ADDENDUM #1

BL000A Site – I69 Section 6 Ilight Relocation Project – BL – South Section
Indiana University Bloomington
Bloomington, Indiana
IU 20250358

ADDENDUM #1

TYPICAL EXISTING HANDHOLE LOCATION WITH GROUND

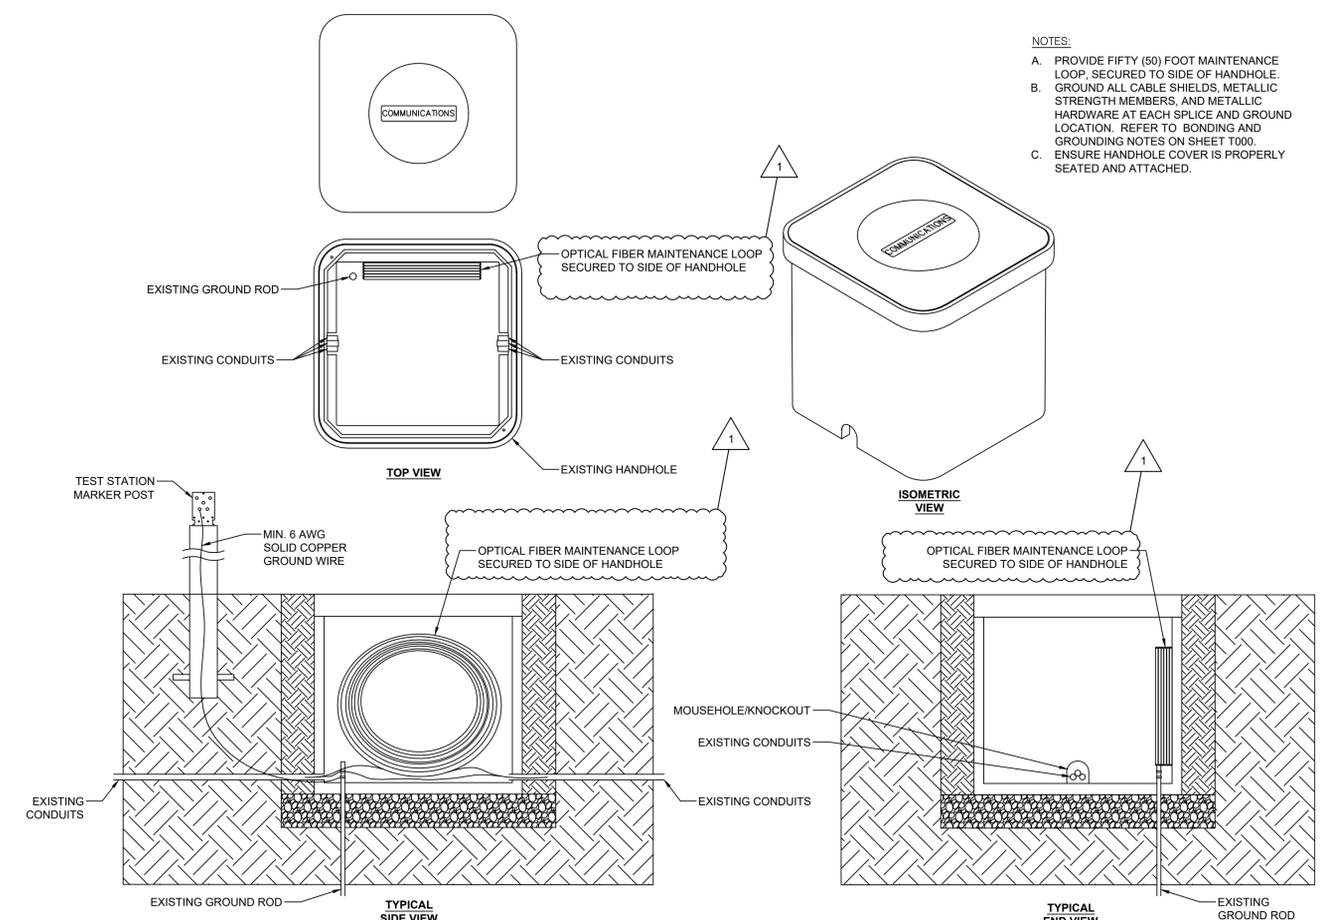
NOTE: There was an error in the detail for grounding handholes which has been corrected and re-issued with this addendum.

Sheet TS002

Made corrections to notes in "TYPICAL EXISTING HANDHOLE LOCATION WITH GROUND" detail.

NOTES:
A. PROVIDE FIFTY (50) FOOT MAINTENANCE LOOP, SECURED TO SIDE OF HANDHOLE.
B. GROUND ALL CABLE SHIELDS, METALLIC STRENGTH MEMBERS, AND METALLIC HARDWARE AT EACH SPLICE AND GROUND LOCATION. REFER TO BONDING AND GROUNDING NOTES ON SHEET T000.
C. ENSURE HANDHOLE COVER IS PROPERLY SEATED AND ATTACHED.
